Town of Parker Community Development Department  
Development Review Division  
Attention: **BrieAnna Simon**

Application Type: **Site Plan**  
Status: **First Referral**  
Application Name: **Douglas 234 F6 AMD 1 L3 – McDonalds**  
Case/AP#: **SP21-067**  
Referral Received: July 14, 2021  
Comments Due: August 12, 2021

Review date: **August 2, 2021**  
Plan reviewer: **Randall L. Capra, [rcapra@parkeronline.org](mailto:rcapra@parkeronline.org)**  
Phone: 303.805.3169

<b>TOWN OF PARKER FIRE/LIFE SAFETY:</b>	<b>R REVIEWED FOR CODE COMPLIANCE; REVISIONS REQUIRED</b>
---	---

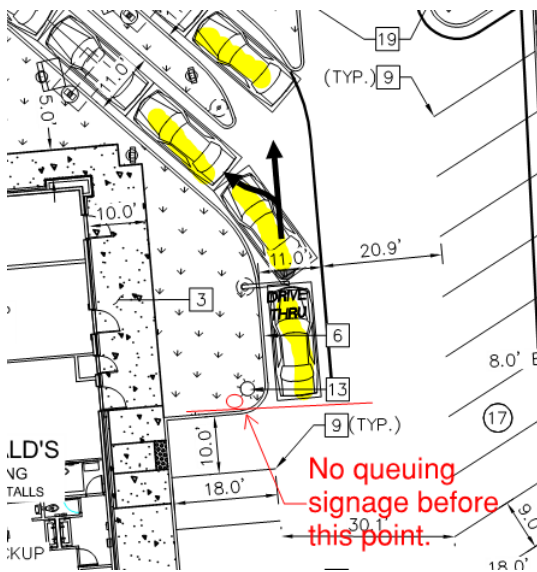
9. The location of the "Drive Thru" is of concern; while the fire code does not address a "Drive Thru", the lack of stacking with regard to the order boards is an issue. This issue was addressed in the pre-application meeting and does not appear to be addressed with this submittal. As evident at the McDonalds located at both the Lincoln and Jordan location and the Parker Road and Mainstreet location, the stacking in these lanes daily obstruct the access in the front (east for both buildings) as cars line up to place orders. This stacking will affect access into the site specific to emergency apparatus, access to the required fire hydrant, and access to the riser room. The stacking will also impact access for other types of emergency response including rescue units, command vehicles, etc. This issue must be addressed moving forward. Note – This issue will only be exacerbated when the proposed high school is constructed in Hess Ranch to the south of this area. *Not satisfied; while applicant has provided a queuing line that appears to keep vehicles internal, based upon usage of drive through lanes at other Parker McDonald's locations, the four cars shown within the queue lines located just before the order screens indicates that the queuing will likely obstruct access through the site as well as corresponding parking located on the south side of the building. While not speaking for Planning and Zoning or for Engineering, it may be feasible for McDonald's to put together a plan that would require management to monitor the queuing lines at peak times (and high usage times)... placing an employee outside the building to direct people out of the queuing line and into a parking stall. Signage would be required that stated "NO CARS ALLOWED TO WAIT IN LINE BEFORE THIS POINT". McDonald's and its Franchisees would be responsible for ensuring compliance or risk having the drive through lanes shut down for lack of compliance in order to ensure that emergency access is not compromised. Note – This is much like what is done for Charter Schools.*
